STATE OF NORTH CAROLINA
DEPARTMENT OF TRANSPORTATION

Subject: DCM Consistency for the proposed US 70 Havelock Bypass in Craven County. TIP No. R-1015. WBS 34360.1.2.

The North Carolina Department of Transportation (NCDOT) submitted additional information on Havelock Bypass to you on March 13, 2020 for review in regards to the Division of Coastal Management's CAMA Consistency Determination for the project. This package included supplemental information and revised permit drawings. Based on further coordination with the NC Division of Water Resources, further revisions need to be made to this request. This letter is a revised version of the March 13, 2020 request, showing additional and modified information highlighted in red.

PROJECT REFERENCE NO. R-1015		SHEET NO. NE-03	
ROADWAY DESIGN ENGINEER		HYDRAULICS ENGINEER	
DOCUMENT NOT CONSIDERED FINAL UNLESS ALL SIGNATURES COMPLETED			
moffatt & nichol		4700 FALLS OF NEUSE ROAD, SUITE 300 RALEIGH, NORTH CAROLINA 27602 919 881-4425 VOIC 919 881-4425 FAX NC License No. F-0105

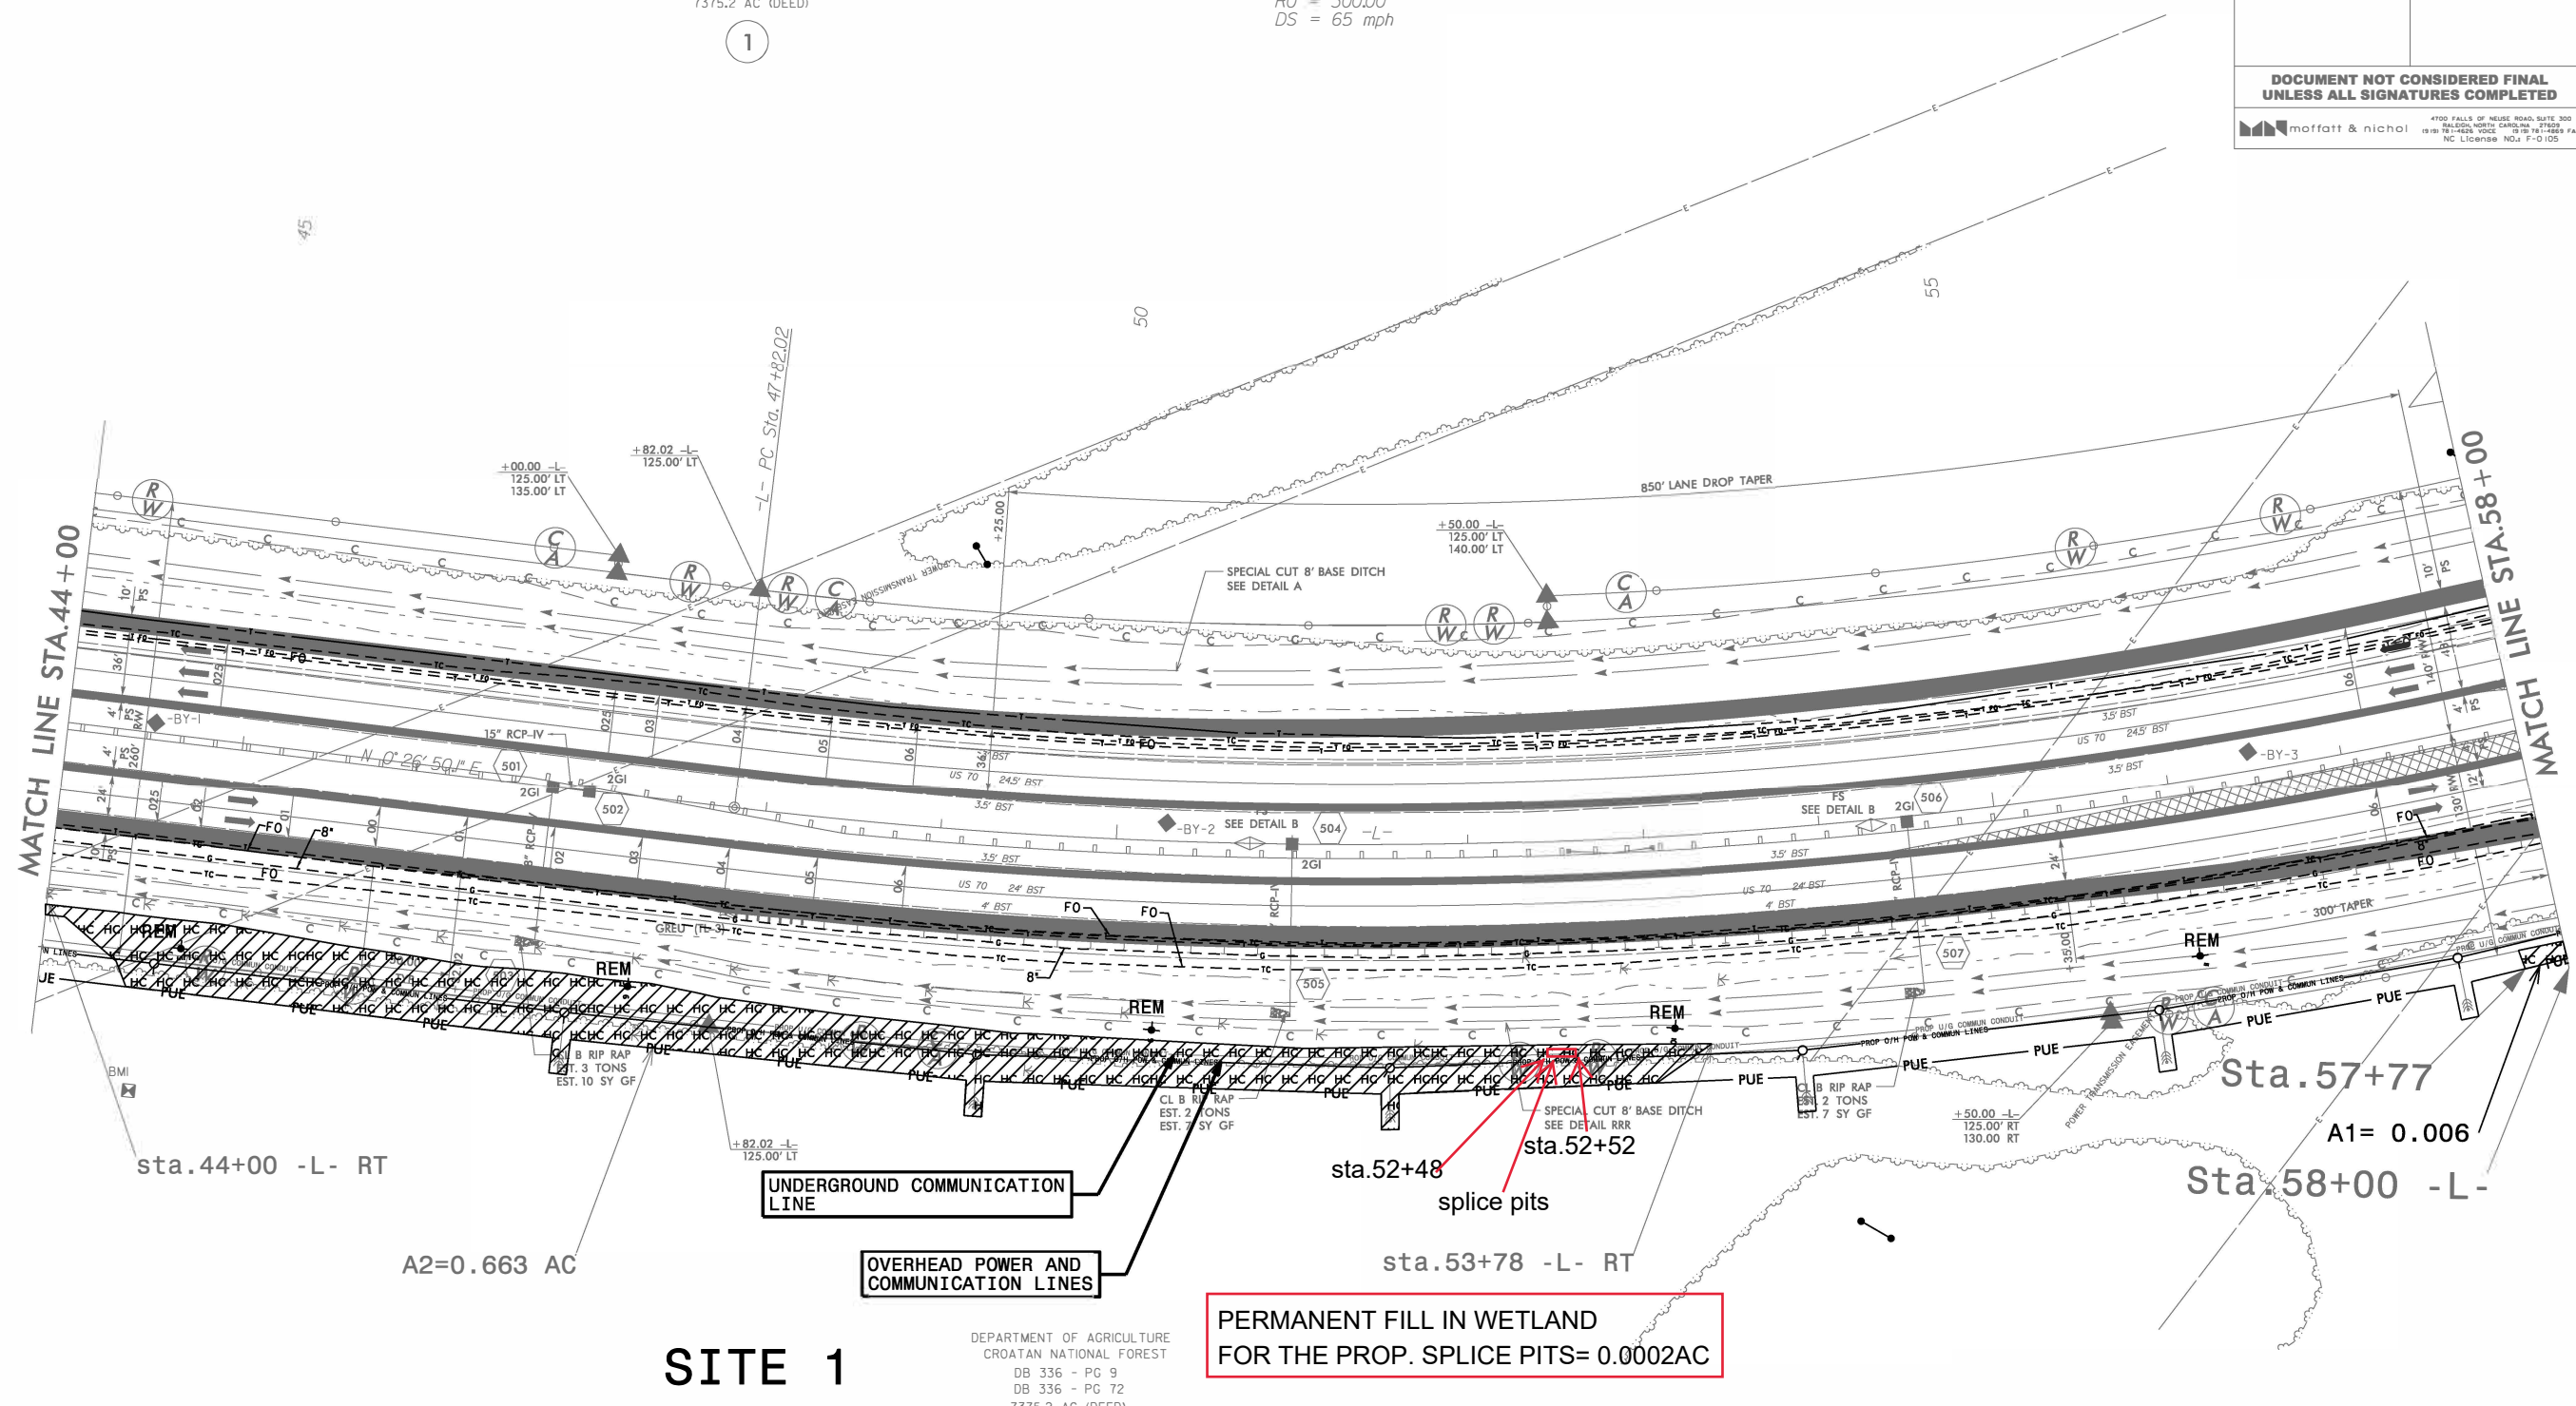
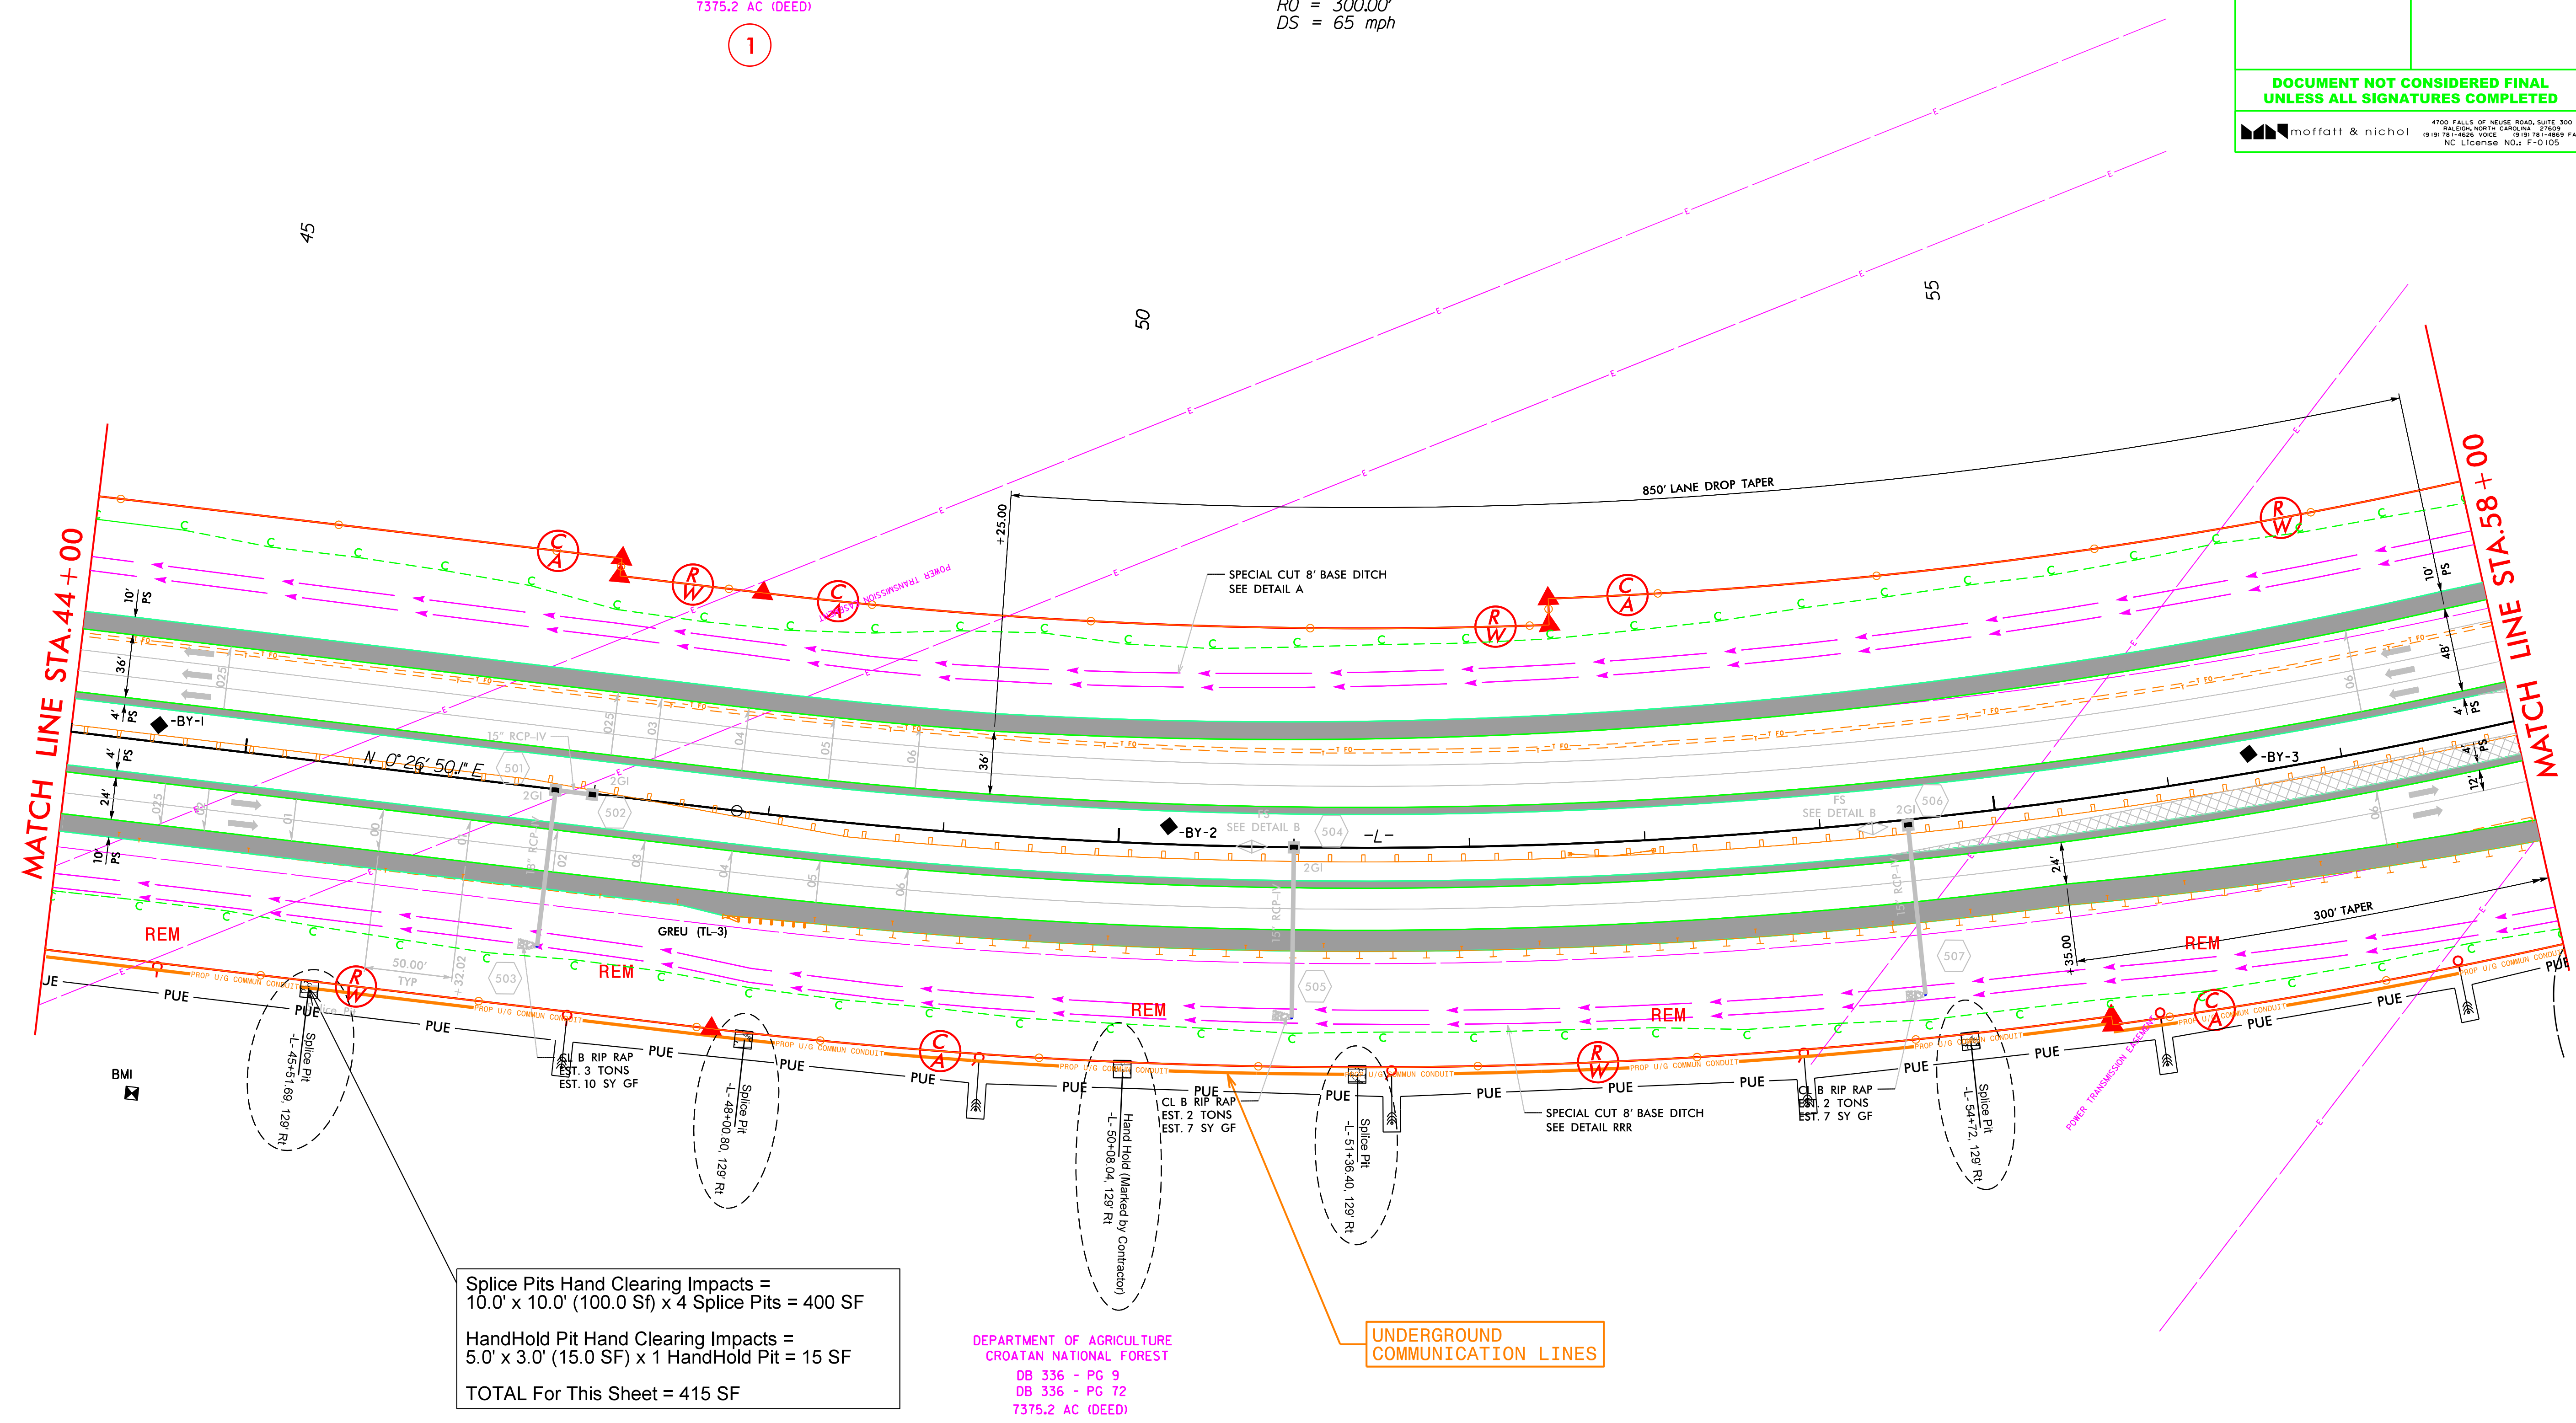
- = NE-03 (Site 1), 409 s.f. for splice pits and 15 s.f. for hand holes
 - = NE-04 (Site 2), 518 s.f. for splice pits and 30 s.f. for hand holes
 - = NE-05 (Site 3), 600 s.f. for splice pits and 30 s.f. for hand holes

- = Additional total impacts needed = 1,602 s.f. (0.037 acre) of excavation and handclearing for bore splice pits and hand holes. Additional coordination with Division 2 staff indicated this work should be counted as permanent impacts. Five utility impact sheets and the utility impact summary sheet have been updated. These three additions can be seen listed at the bottom of the site list as excavation impacts.

**BUFFER DRAWING
SHEET 13 OF 20**

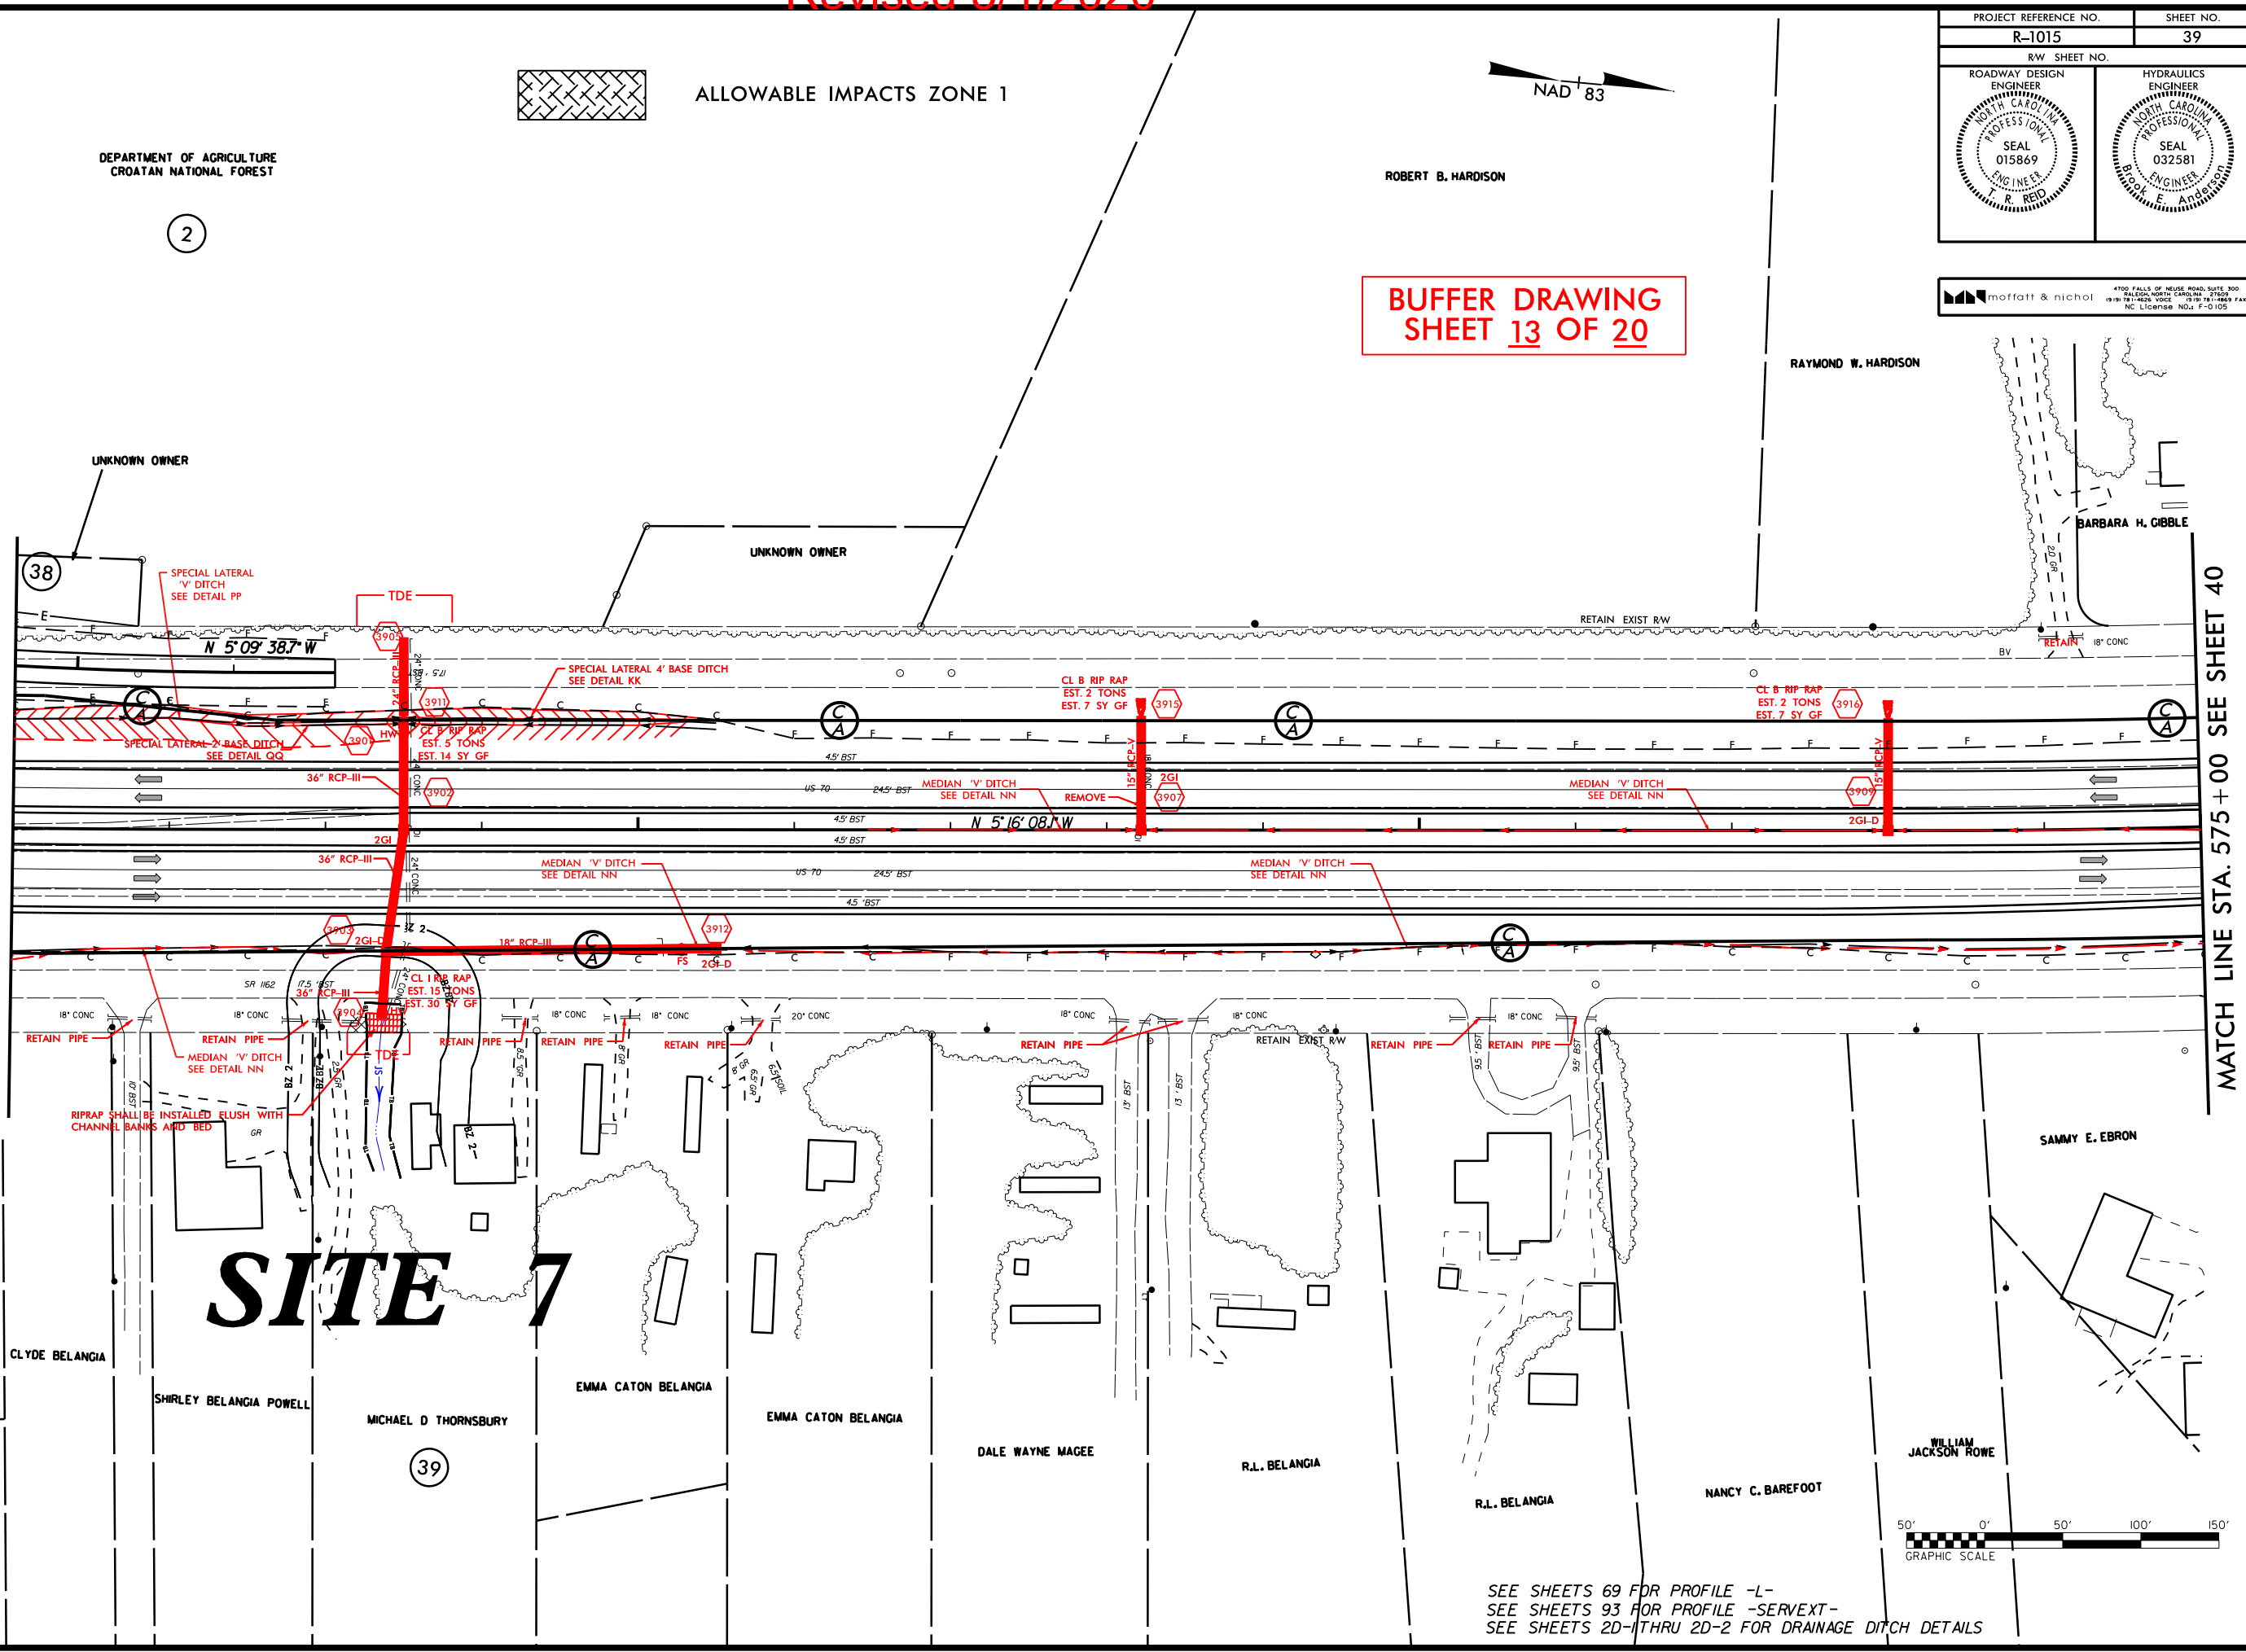
- Site 7 (buffer sheet 13) reduced Allowable Zone 1 impacts by 282 s.f. The pipe was shortened to eliminate easement on a property, and a headwall added.
- Summary updated (buffer sheet 18 & 19). Allowable Zone 1 impacts are reduced from 42,810 s.f. to 42,529 s.f. due to the changes at Site 7.
